Access Compliance Report Public Rights-of-Way (Curb Ramps)

Intersection ID: 51356 Main Street: BRENTMOOR DR **Cross Street: PEARL ST** Location: **Overall Compliance: No** ADA ID: 36787FAA2AAB Ramp Type: BlendTrans1 Initial Pass/Fail: Pass Severity Score: 10.25

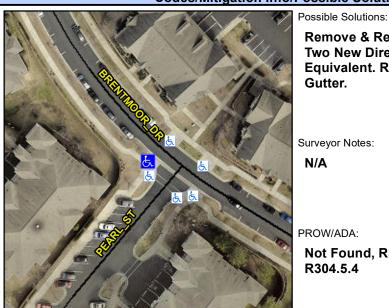
Not **R30**

W// ND/ N.	
t Found, R304.5.3, R30 04.5.4	4.2.3,

BRENTMOOR DR Street 1 Name Stop Condition-Street 1 None Street 2 Name N/A Stop Condition-Street 2 N/A Remove & Replace Curb Ramp With Two New Directional Ramps or Equivalent. Remove & Replace Gutter.
